Deck Repair

MERIDIAN FIRS LLC

(Construction Plans, Sheet A1.1)

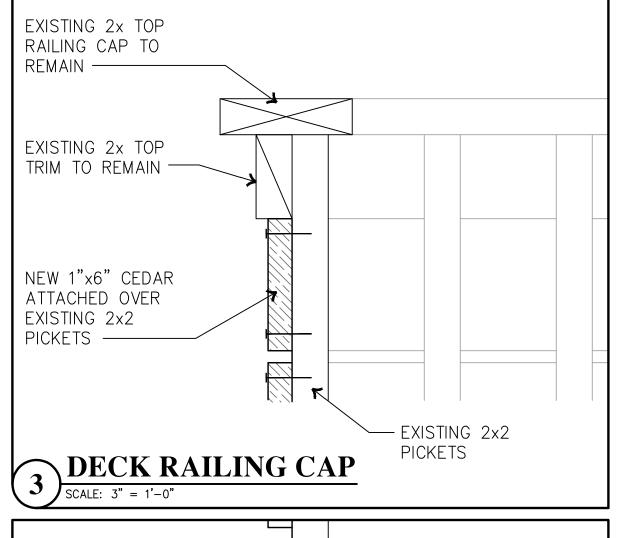
Provide specifics of the plywood that will be installed which should include plywood thickness, grade and any other specifics that will reflect that the plywood will withstand the dead and live loads of the deck. Identify the non-slip surface that will either be provided on the plywood or will be added to the plywood as part of construction, as notated on sheet A1.0, Owner/Contractor Coordination Notes.

The existing joist spacing should also be considered when selecting the plywood material that will be used. Please provide the existing joist spacing.

Updated all details and notes as needed to reflect the requested information.

(Construction Plans, Sheet A1.1)

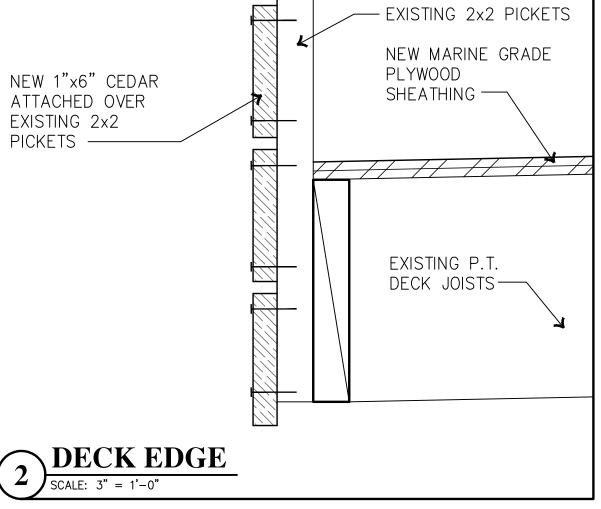
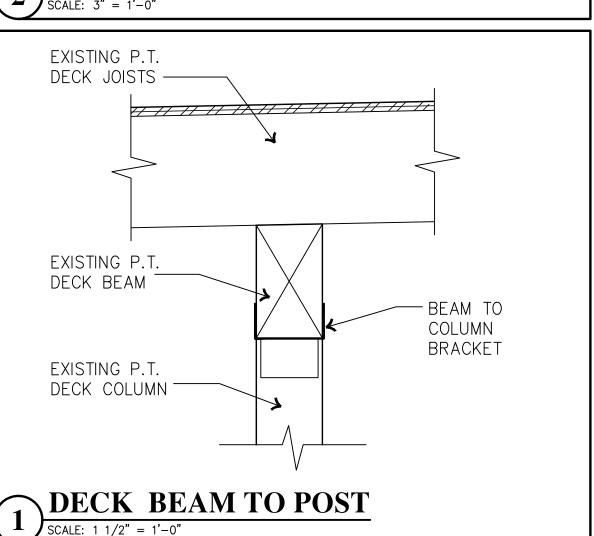
Deck joists appear to be sloped to drain off of the cantilevered side of each deck based upon details 1 and 2. Detail 2 shows the installation of the 1x6 cedar board over the existing 2x2 balusters. detail or notate how the 1x6 cedar will be installed to prevent drainage and water accumulation on the deck surface.

(Construction Plans, Sheet A1.1)

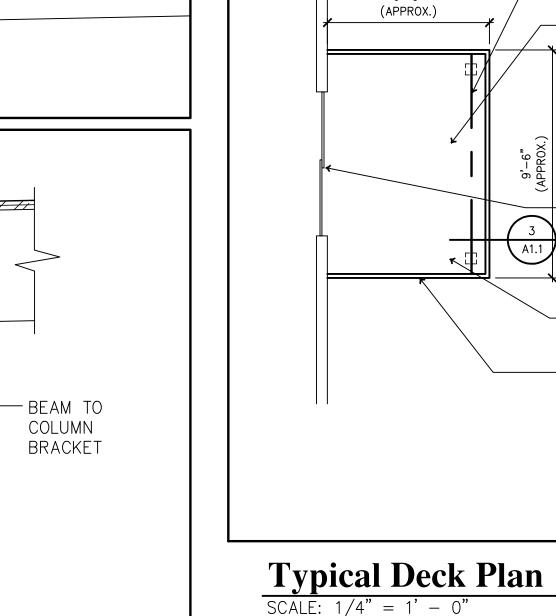
Add a notation on either Sheet A1.0 or A1.1 that contractor shall verify the integrity of balusters prior to the installation of the 1x6 cedar. Establish the parameters of the balusters replacement to include type, grade and nailing pattern.
